## Development Review Division

**TO:** Ryanne Sass, Plaza Street Partners  
**FROM:** Stacey Nerger, Senior Planner  
**DATE:** January 3, 2022  
**SUBJECT:** Lincoln Professional Park – Preliminary Site Plan  
Review Comments 02

# LINCOLN & DRANSFELDT FILING NO. 1

CONCEPT OVERALL SITE PLAN

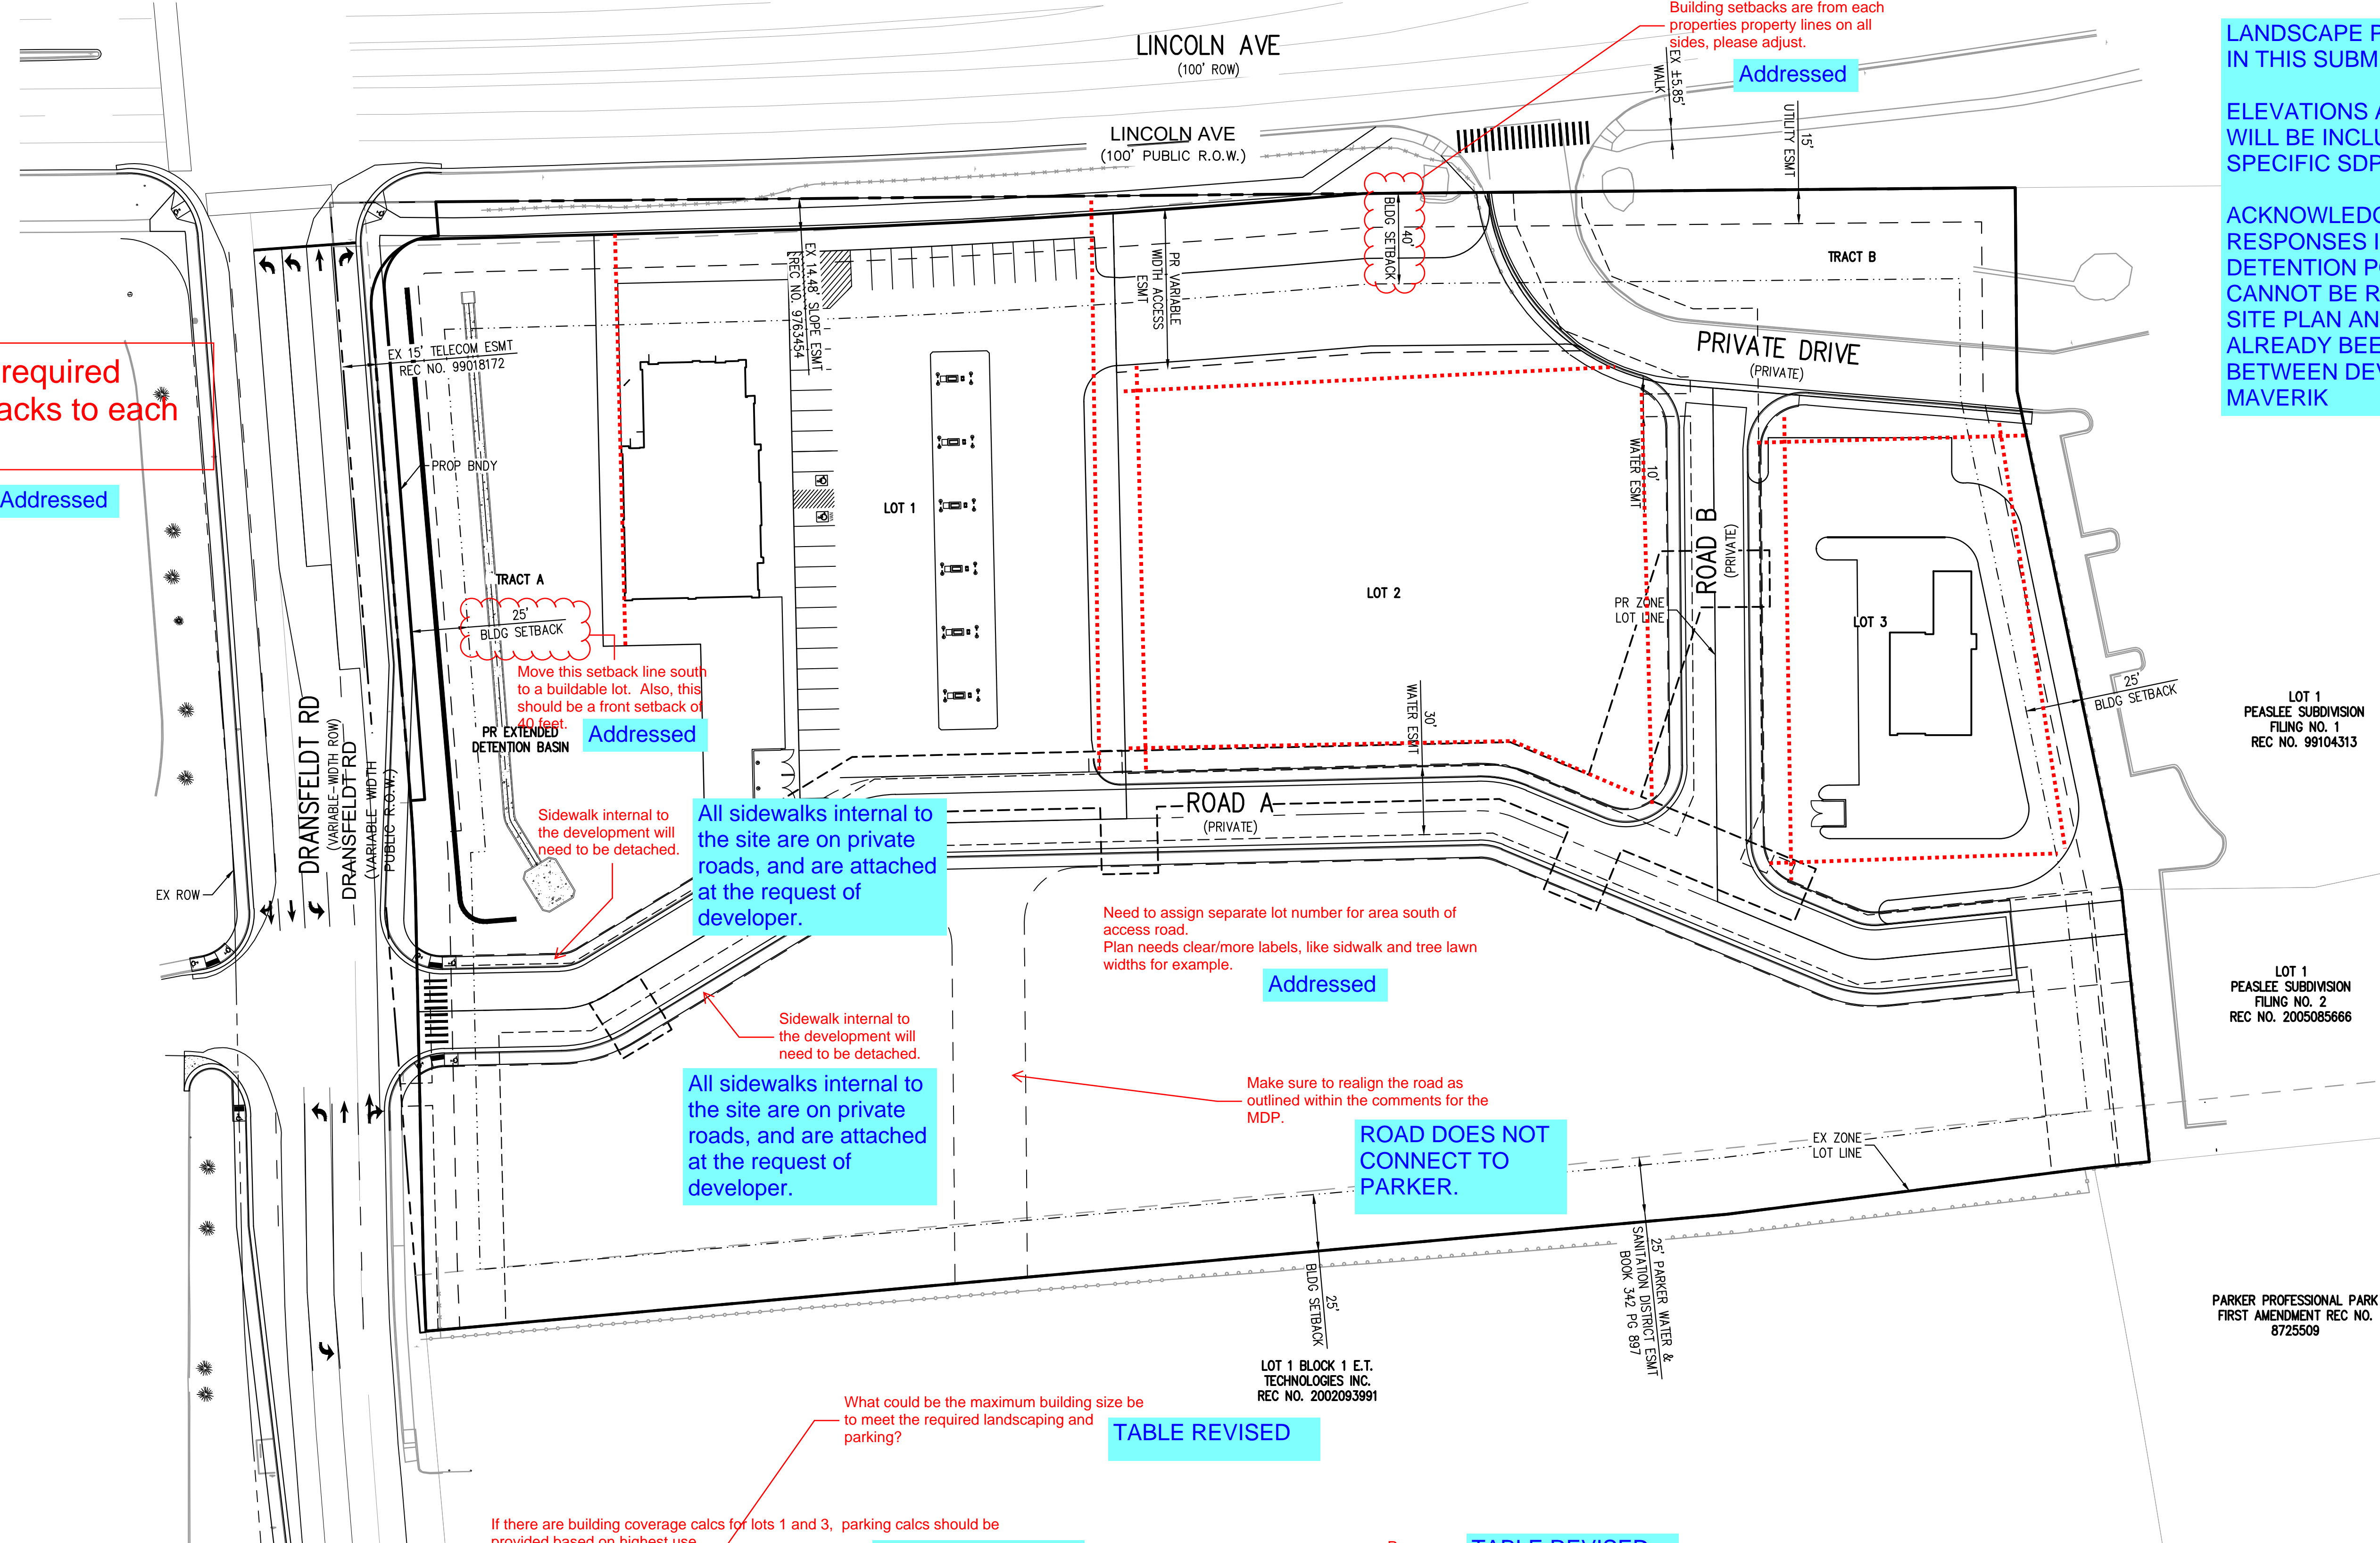
Please create a cover page that includes the following:  
 1. Vicinity Map  
 2. Land Use Summary Table  
 3. Legal description

Title for the Preliminary Site Plan should be as follows:  
 Lincoln Professional Park Filing No. 1  
 Preliminary Site Plan

Please review last comments. Do not submit until all required documents have been completed, specifically documents related to landscape comments.

Additionally, comments related to elevations and lighting have not been addressed. This is required as part of a preliminary site plan submittal.

Most previous redline comments from staff have not been addressed and no explanation has been provided.

Add required setbacks to each lot.

Need to assign separate lot number for area south of access road. Plan needs clear/more labels, like sidewalk and tree lawn widths for example.

Make sure to realign the road as outlined within the comments for the MDP.

What could be the maximum building size be to meet the required landscaping and parking?

If there are building coverage calcs for lots 1 and 3, parking calcs should be provided based on highest use.

Add a column that the maximum height for the zone district is 35 feet and can be satisfied for all buildings on site.

Addressed

LANDSCAPE PLANS INCLUDED IN THIS SUBMITTAL

ELEVATIONS AND LIGHTING WILL BE INCLUDED IN THE SITE SPECIFIC SDP PACKAGES

ACKNOWLEDGED, SEE RESPONSES IN THIS LETTER. DETENTION POND FOOTPRINT CANNOT BE REDUCED. LOT 1 SITE PLAN AND ACREAGE HAS ALREADY BEEN FINALIZED BETWEEN DEVELOPER AND MAVERIK

Addressed

All sidewalks internal to the site are on private roads, and are attached at the request of developer.

All sidewalks internal to the site are on private roads, and are attached at the request of developer.

Addressed

ROAD DOES NOT CONNECT TO PARKER.

TABLE REVISED

TABLE REVISED

Addressed
